Technical Service Bulletin

Topic	Mulsanne steering shimmy/vibration - 21 Inch wheels only (USA)
Market area	United States E05 Bentley USA and rest America (6E05)
Brand	Bentley
Transaction No.	2030349/3
Level	EH
Status	Released for publishing
Release date	May 20, 2019

Bentley Mulsanne

Figure 1

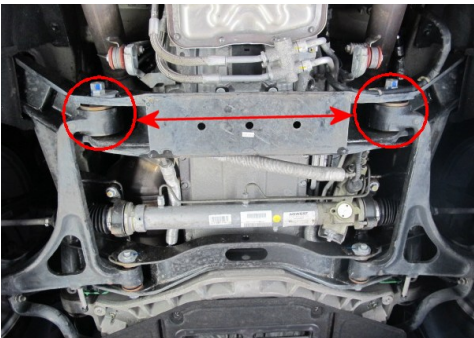
Referring to Figure 1, from VIN SCBBA63Y9BC016115 the front suspension lower lever inner rear bushes with a higher damping frequency were fitted at the time of production.

Figure 5

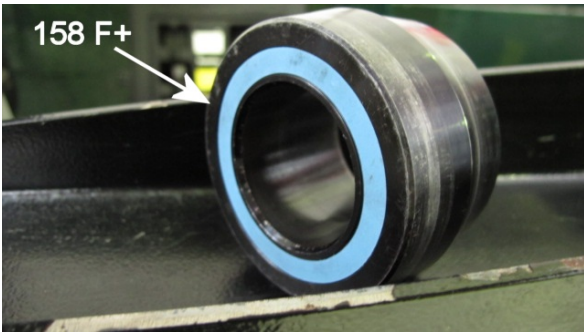
- For applicable Hunter machines, it is imperative that the adaptor cone with part number 158 F+ with a light Blue coloured face as shown in Figure 5.
- The cone must be fitted on the spindle as shown in Figure 6 ensuring the light Blue face of the cone is facing towards the end of the spindle

Figure 7

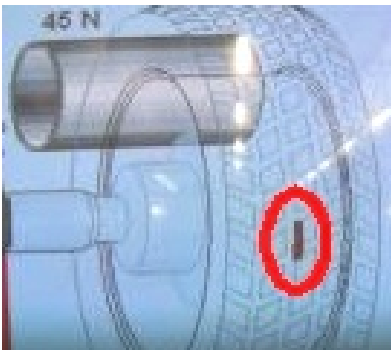
- Once the force matching process is complete, the assembly high spot is identified with a brown dash (Figure 7).
